AMENDMENT UNDER 37 C.F.R. § 1.111
U.S. Application No.: 10/091,445

For: CERAMIC HEATER

REQUEST FOR APPROVAL OF PROPOSED DRAWING CORRECTIONS

Fig. 7 PRIOR ART

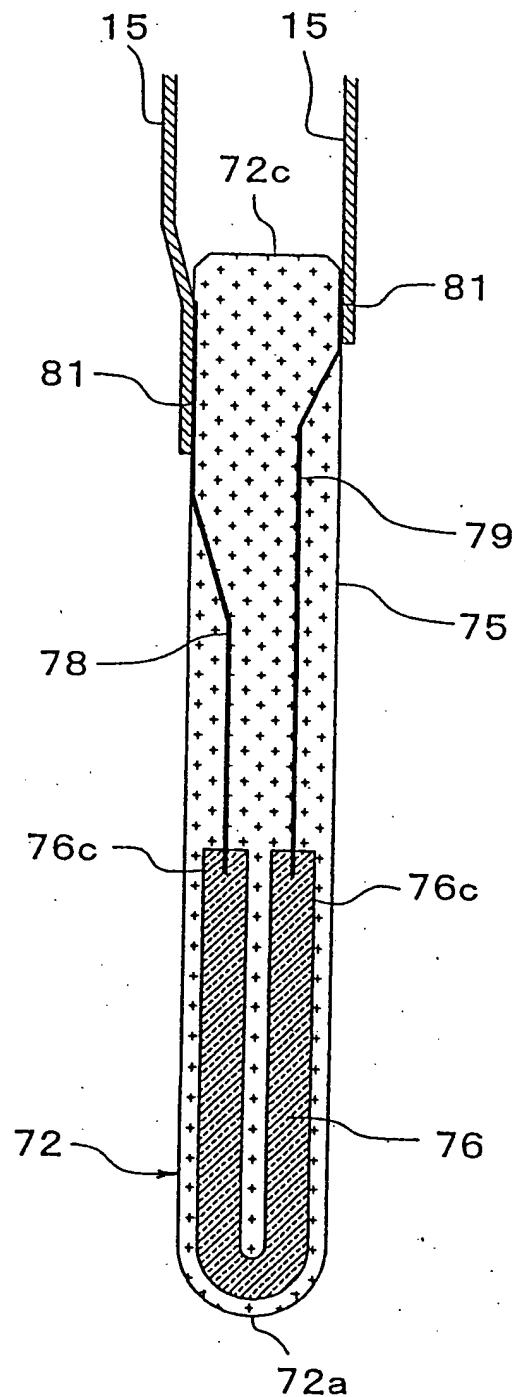
Fig. 7 is amended to be labeled as "PRIOR ART".
